Z-57
(2017)

ZONING
PLAT

ZONING COMMENTS:

PLANNING COMMENTS:

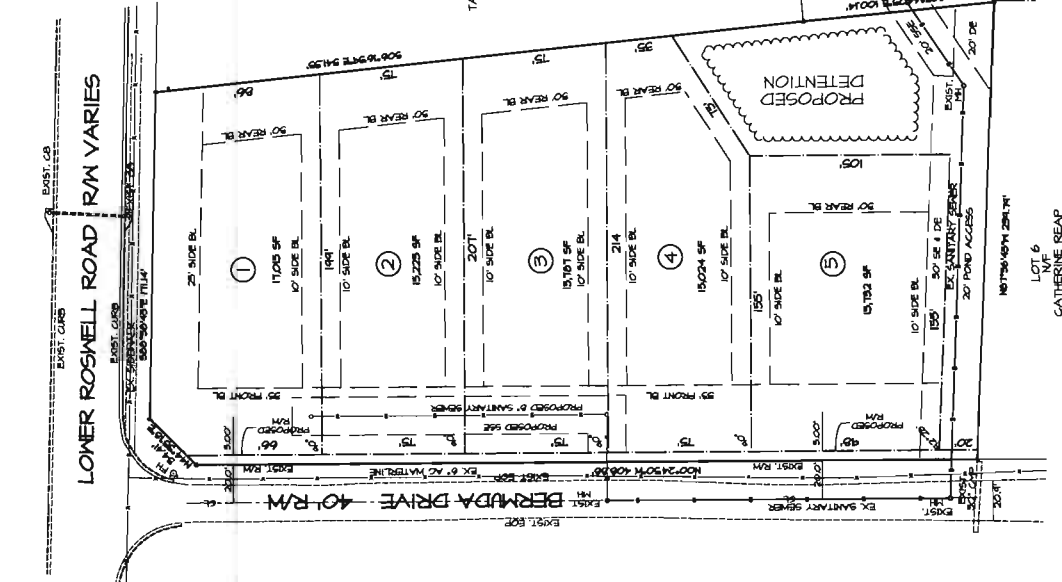
REVISIONS
14 AUGUST 20, 2017 PER COUNTY COMMENTS
